WOLF CREEK

ET 92-0103

Reference: 1) Letter dated December 27, 1991 from W. D. Reckley,
USNRC, to B. D. Withers, WCNOC
2) Letter ET 90-0140 dated August 21, 1990, from
F. T. Rhodes, WCNOC, to the USNRC
Subject: Docket No. 50-482: Response to Request for Additional
Information on the Core Thermal-Hydraulic Analysis
Methodology for the Wolf Creek Generating Station

Response to Request for Additional Information
for the Core Thermal Hydraulic Analysis Methodology
for the Wolf Creek Generating Station

Figure 19-1

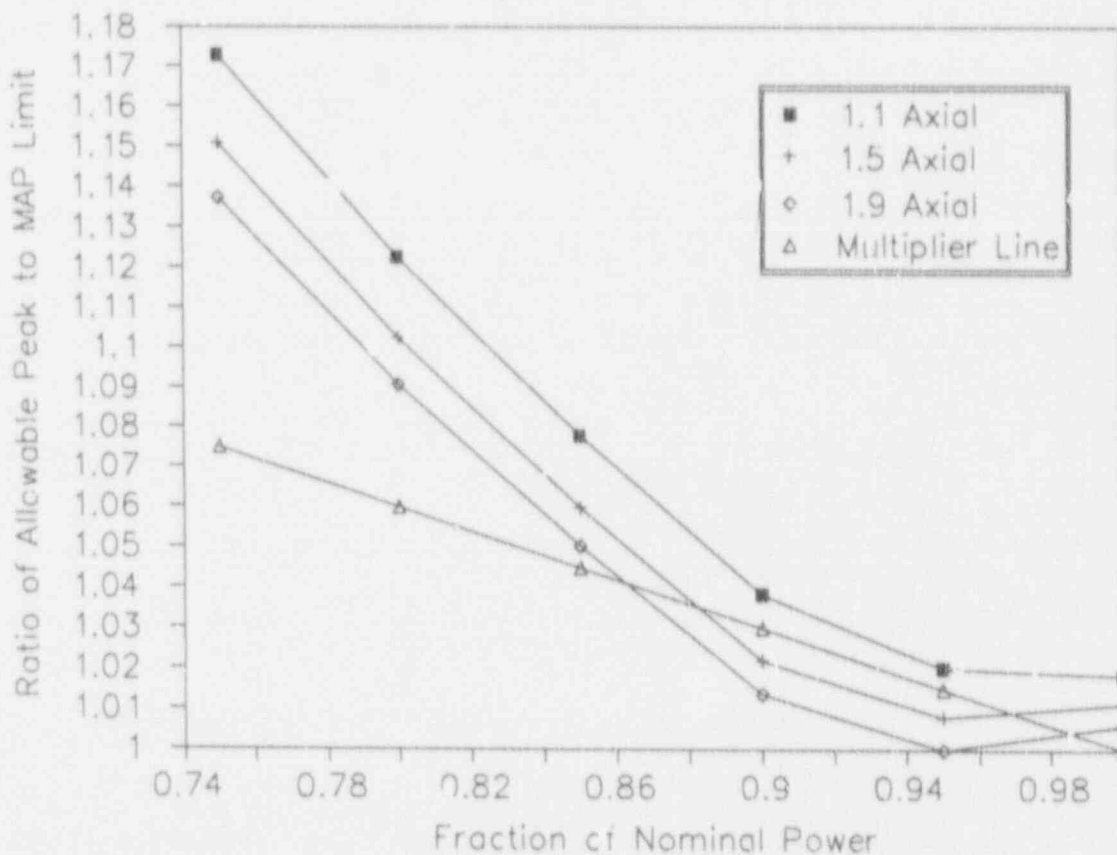
Request 19: Why are the curves in Figures 6-13 and 6-15 different?

The MAP limits shown in Figure 6-13, TR-90-0025 were adjusted, in the more restrictive direction, as a result of the analysis to establish the part power multiplier. As shown in Figure 19-1 below, use of a part power multiplier constant of 0.3 would result in slightly non-conservative results when the ratio of the power allowable peaks is compared to the unadjusted safety limit MAP's. To account for this, the limiting safety limit MAP's were reduced by 1.6%. As shown in Figure 6-14, TR-90-0025, this insures that the peaking restrictions imposed by the safety limit MAP's are conservative at all powers. Figure 6-15, TR-90-0025 is simply the maximum allowable peaking limits shown in Figure 6-13, TR-90-0025 reduced by 1.6%.
